Subject: Project name Temple Isaiah - Addition
Project site address 12200 Scaggsville Road, Fulton MD 20759
Permit # B21004881 SDP # SDP-02-155
Other information pertinent to this project _____

**Permit #B21004881 Response,
Permit Comments
Narrative Letter 4**

Date	April 29, 2022
Project	Temple Isaiah

ELECTRICAL OVERALL
FIRST FLOOR LIGHTING
PLAN
RECEIVED
MAY 06 2022
LICENSES & PERMITS
E201L

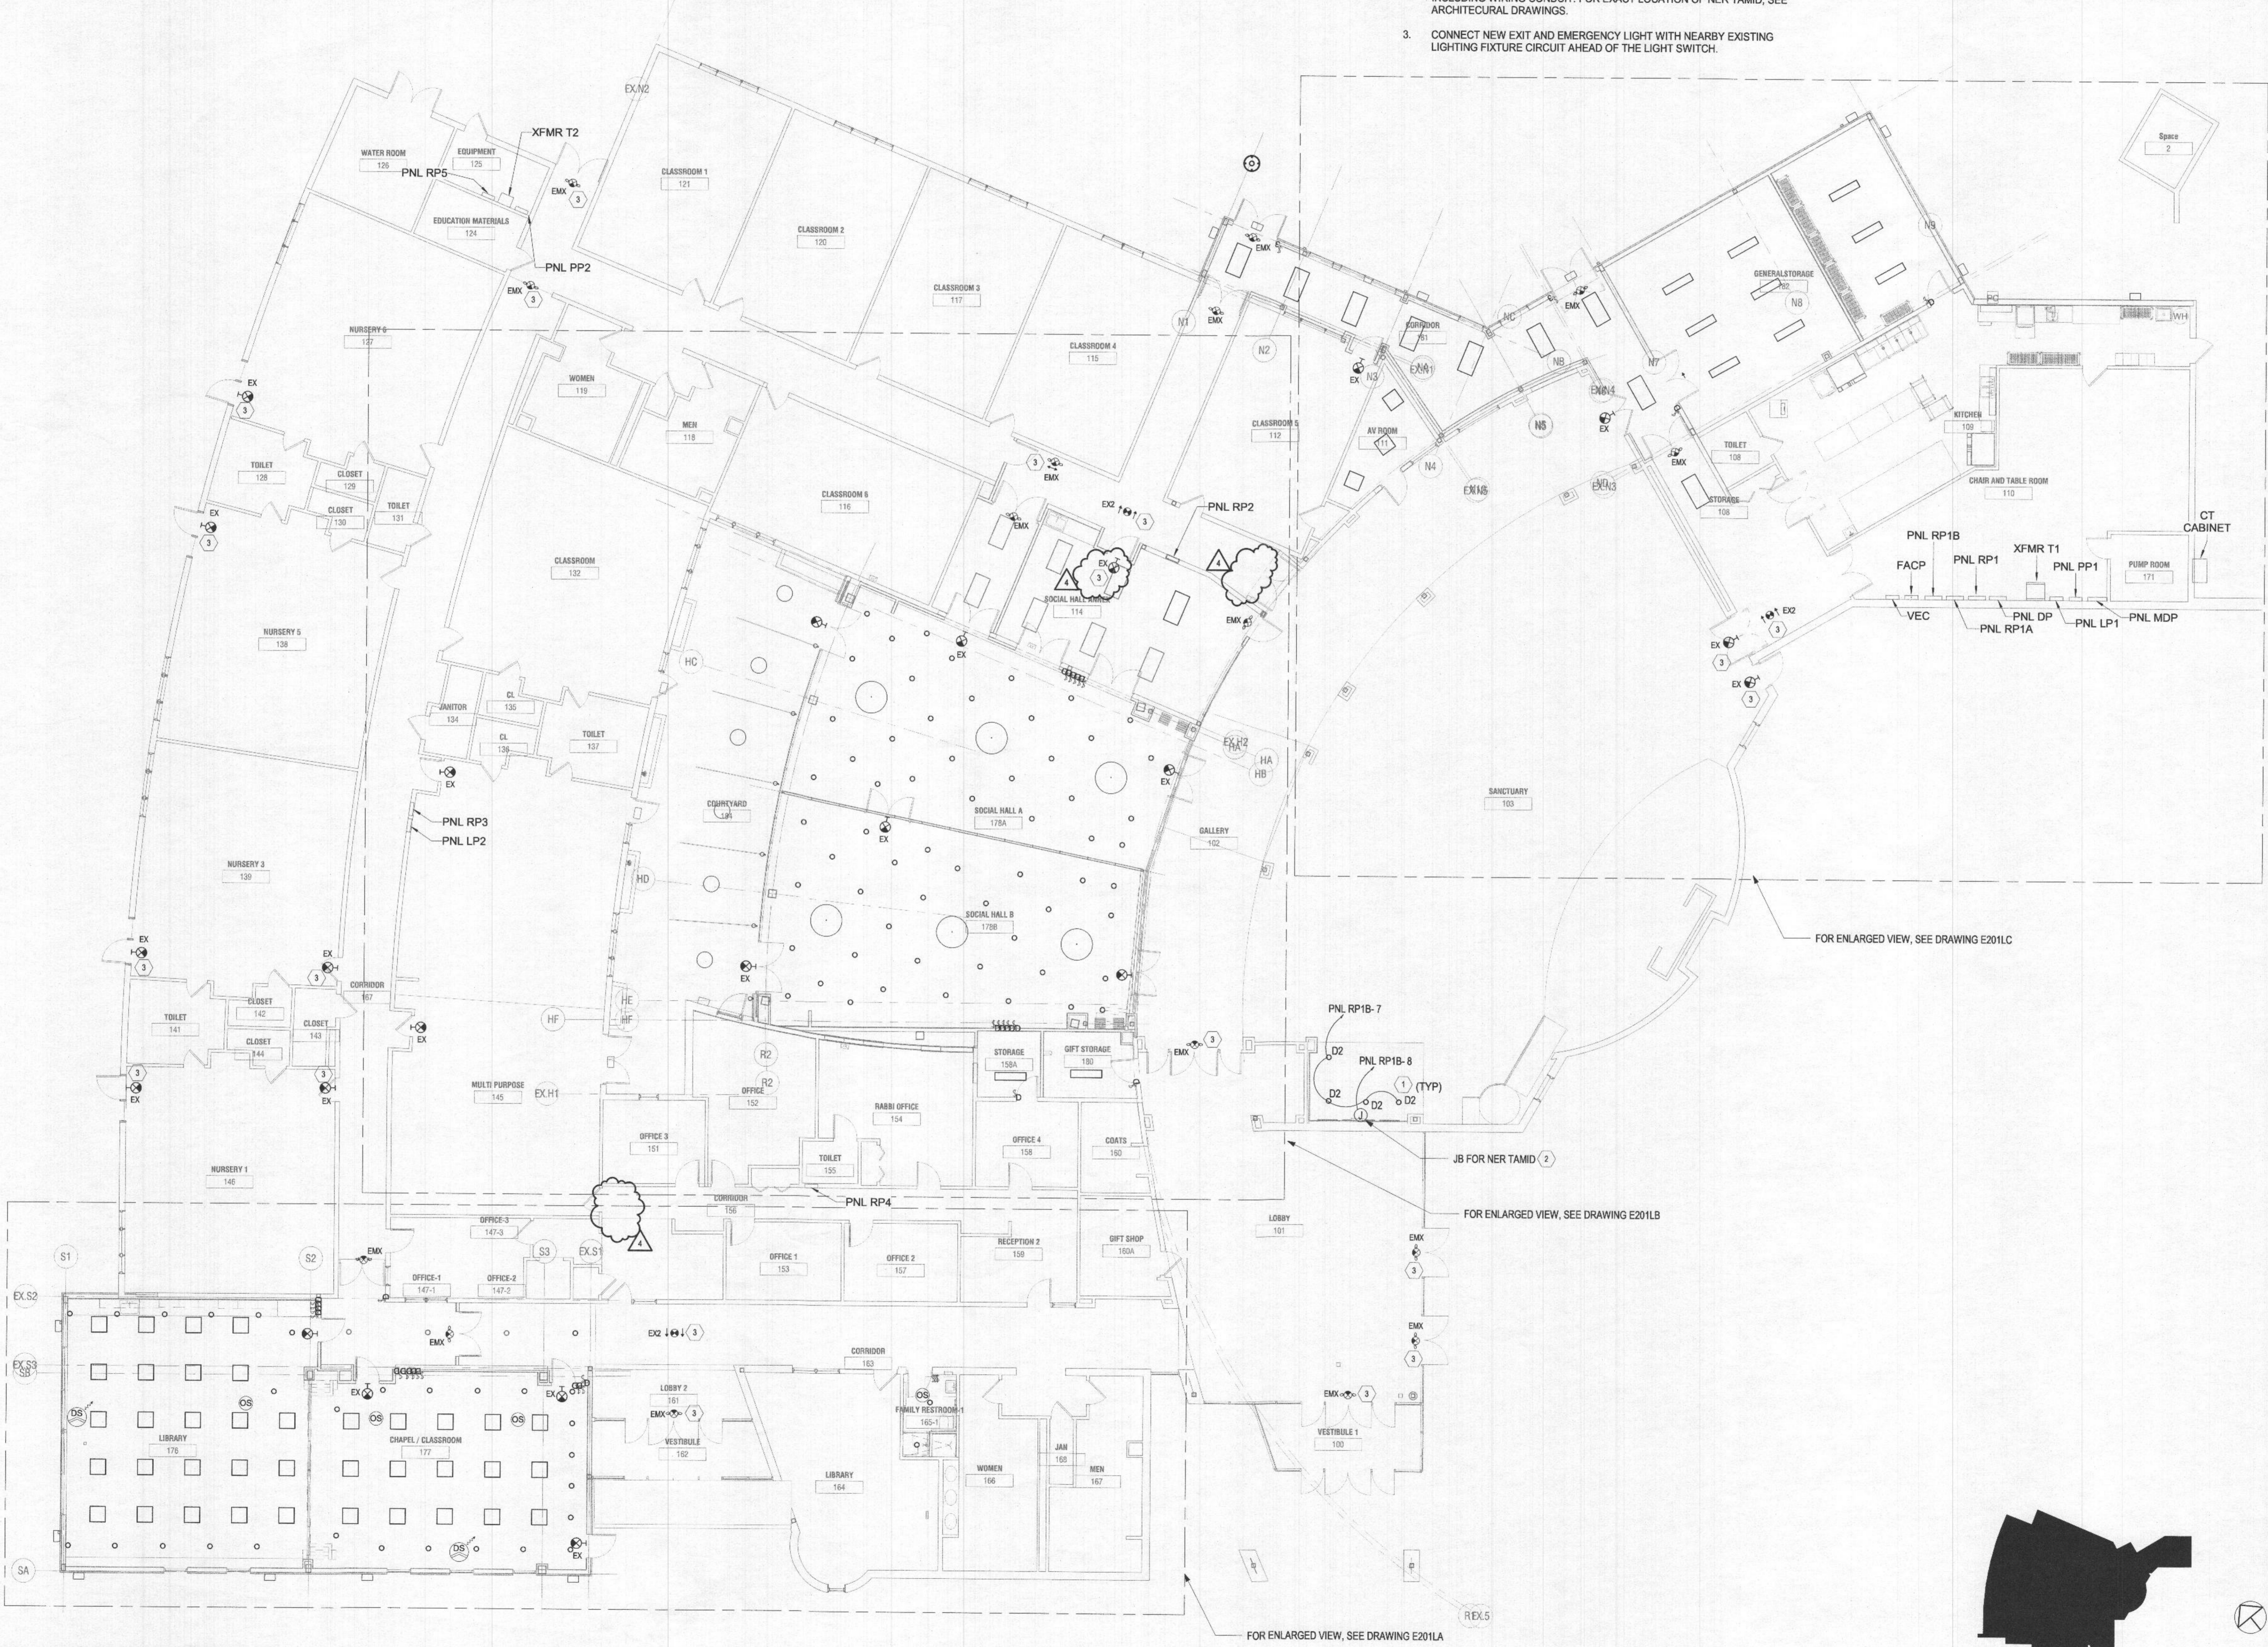
10- Drawing E201L does not have an exit sign in front of corridor door 123. Please provide an exit sign or explain

- *Exit sign has been added.*
